Issue

EmStat Pico MUX16 pinout correction

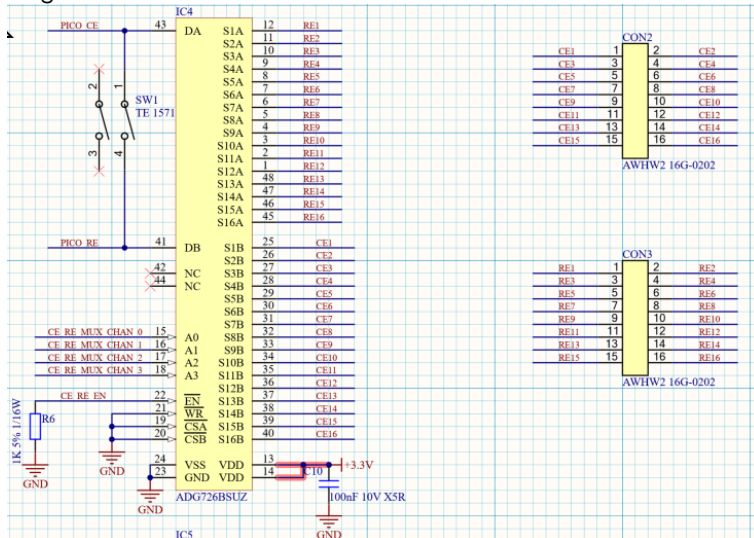
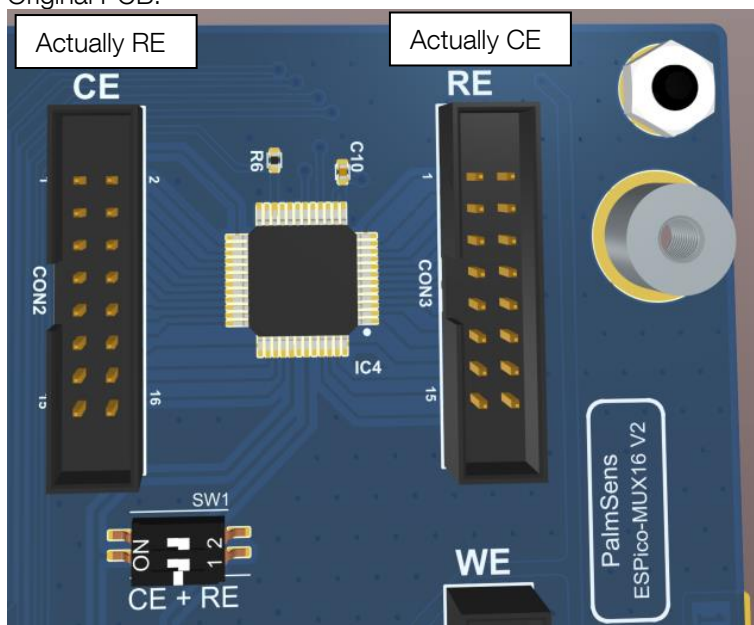
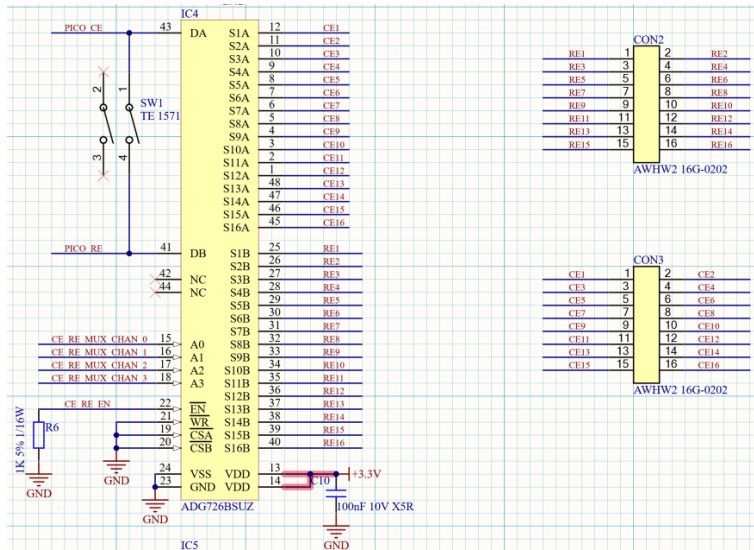
CE and RE were switched so that CON3 was CE1 to CE16 and CON2 was RE1 to RE16.
